Product Change Notification / SYST-06AUDA206

ERRATA - ATtiny3216/3217 Silicon Errata and Data Sheet Clarification Document Revision

ATtiny3216/3217

Silicon Errata and Data Sheet Clarifications

Figure 3-1. Block Diagram

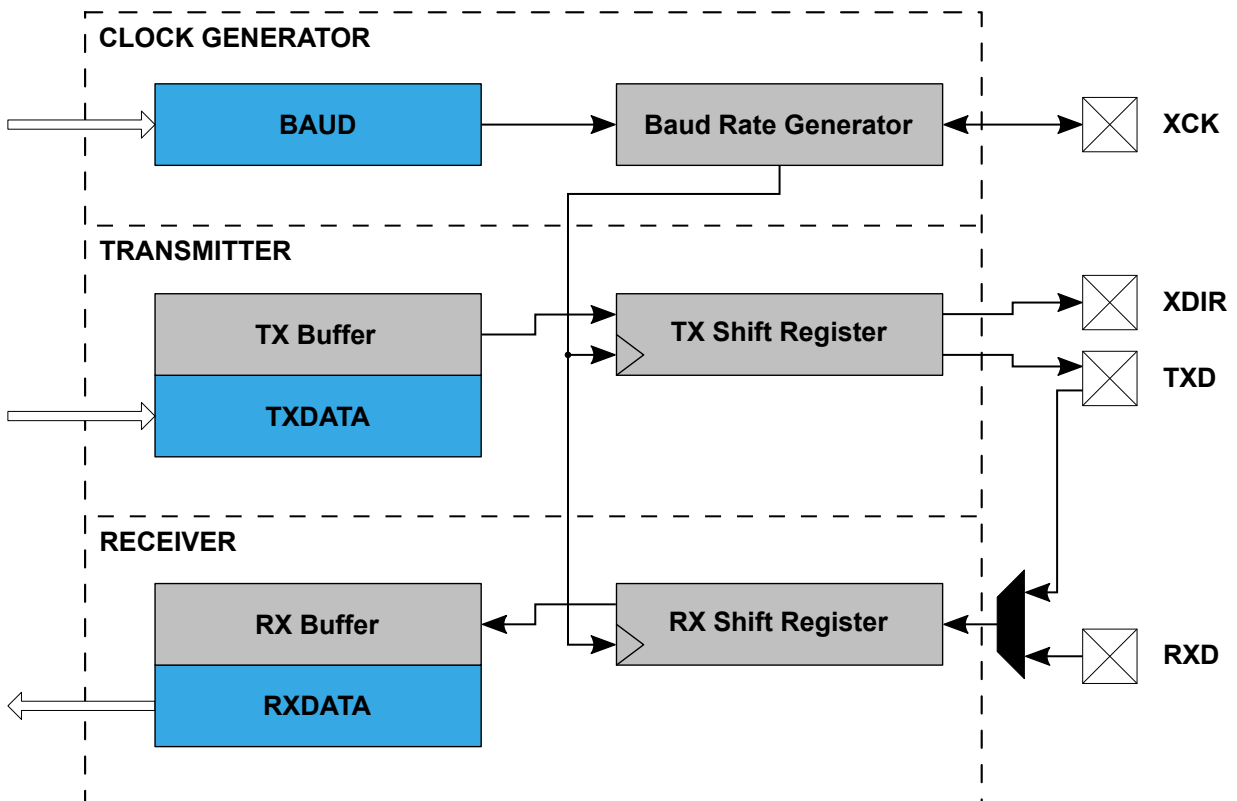
3.3.1 TXDATA Buffer

The block diagram is missing that USART TX is double-buffered from Figure 25-1 in the data sheet. The figure below shows the added **TX Buffer**.

The following text is changed in the *Overview* section:

The transmitter consists of a **two-level** write buffer.

The following text is changed in the *Data Transmission* section:

The data transmission is initiated by loading the **Transmit Data (USARTn.TXDATAL and USARTn.TXDATAH)** registers with the data to be sent. The data in the **Transmit Data registers** are moved to the **TX Buffer** once emptied and then to the Shift register once it is empty and ready to send a new frame.
